ADDENDUM NO. 2  
TO REQUEST FOR PROPOSALS  
FOR  
ADVANCED METERING INFRASTRUCTURE (AMI) SYSTEM

EOCWD Retail Site Boundary Exhibit

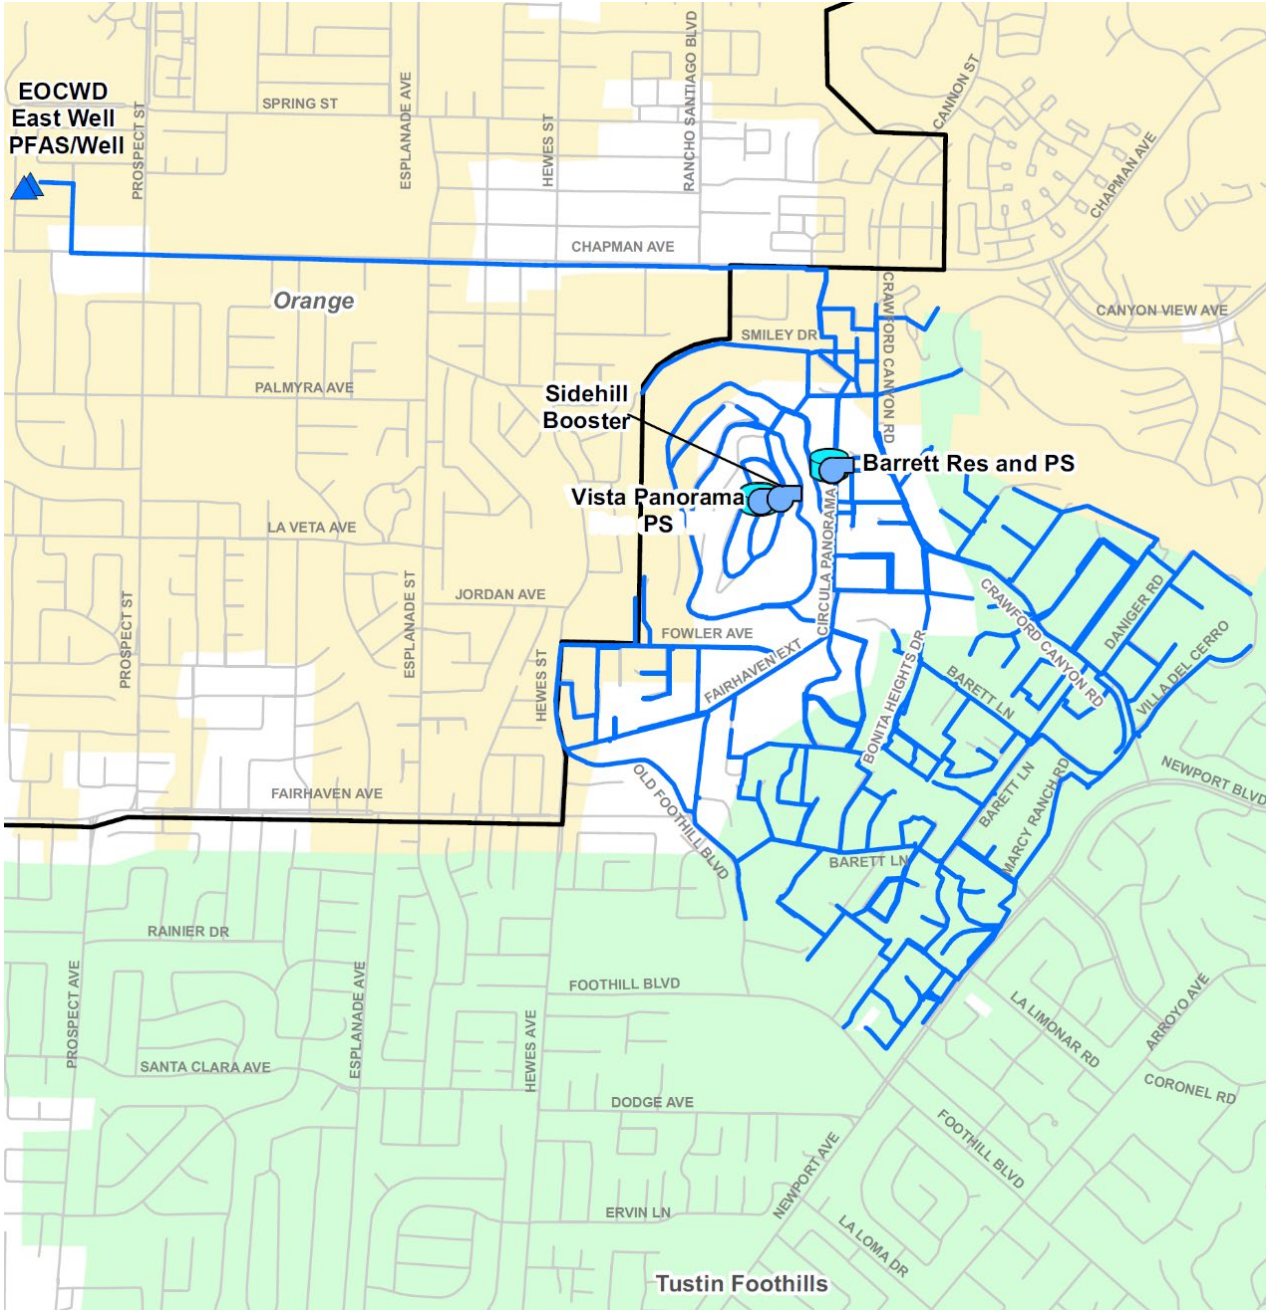
2. Please see attached map at the end of this Addendum for overall EOCWD retail site boundaries.
